# Mitchells Way / Barnsley Road, Wombwell

Road Safety Audit  
Stage 1  
October 2018

Project No: 1386

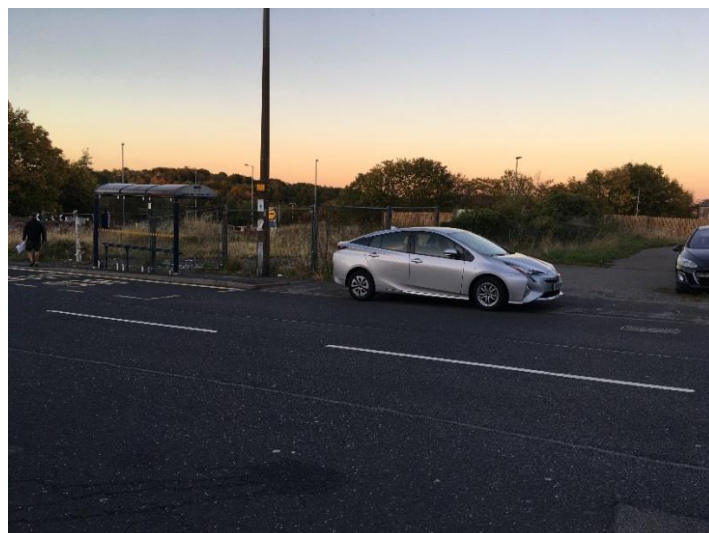
**Summary:** Risk of collisions due to parked vehicles & congestion.

**Detail:** It was observed on site that parking occurs on the road especially at night by residents to the south of the access road and customers to the shop and take-away opposite, (See Image below). This parking may obstruct sightlines when accessing and egressing the new petrol station. The addition of a new access will generate more vehicle movements at this point and could increase the risk of collisions at this location.

**Recommendation:** Monitor the parking and review the restrictions in the vicinity of the proposed access.

# APPENDIX B – PROBLEM LOCATION PLAN

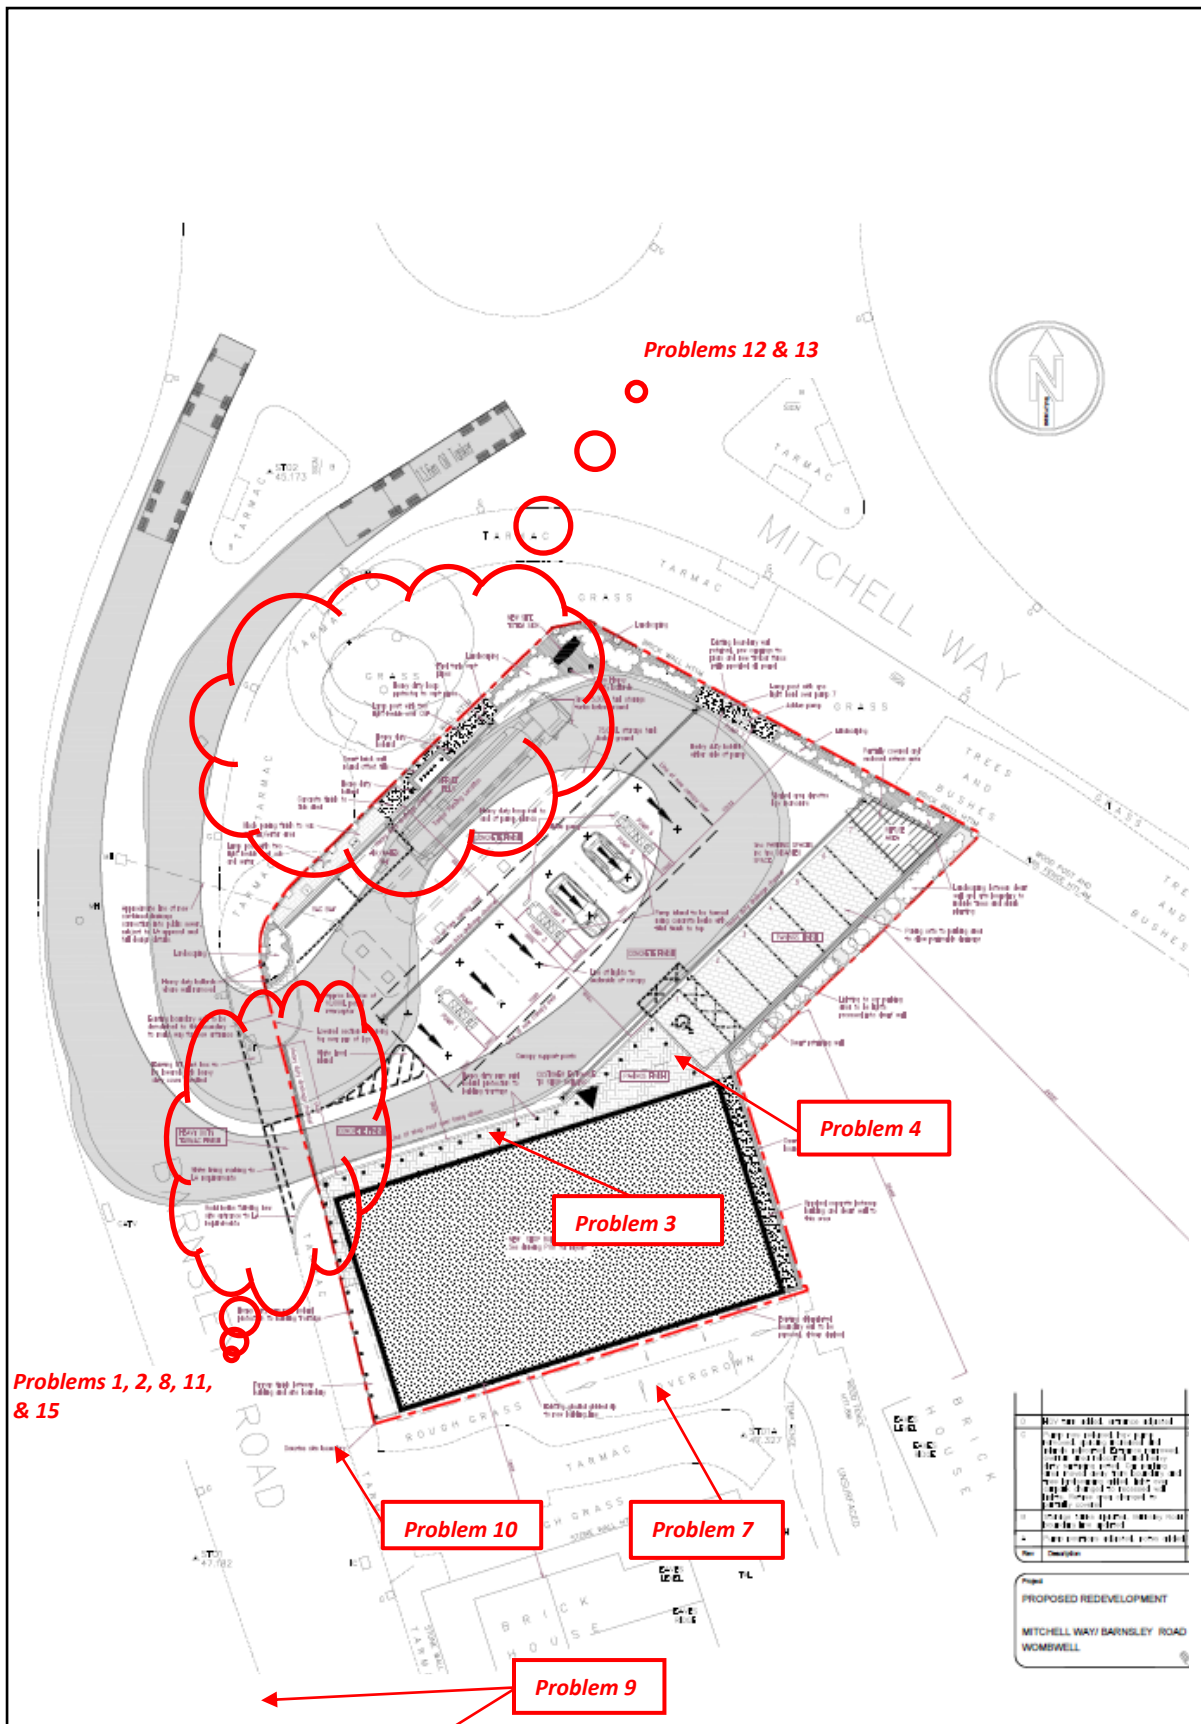
**Detail:** No lighting details on the highway have been included in the proposals to serve the new access road and junction. There is an existing lamp column (See Image below) on the south side of the site boundary but no details have been provided to suggest it is being relocated or if the new access is sufficiently illuminated. If the junction is not suitably illuminated there is a risk that vehicles may not see pedestrians.

- Problem 5 – Forecourt Canopy**
- Problem 6 – Swept Path**
- Problem 14 – One Way signs**

**Recommendation:** Provide adequate street lighting for the proposed development and at the junction.
